Access Compliance Report Public Rights-of-Way (Curb Ramps)

Main Street: LA_COLINA_DR Cross Street: BROWNING_AVE Location: SW

ADA ID: RPRK211014134314 Ramp Type: Type 4 - Parallel Initial Pass/Fail: Pass Overall Compliance: No Severity Score: 0

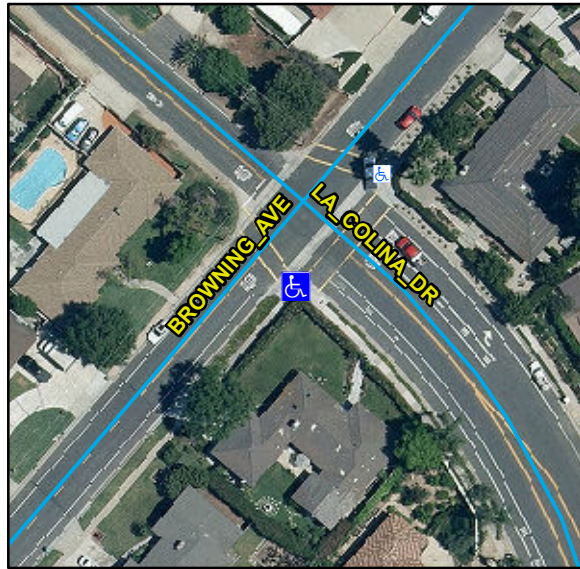
R304.2.2, R304.5.3, STD 1115

Remove & Replace Curb Ramp With Two New Directional Ramps or Equivalent. Remove & Replace Gutter.
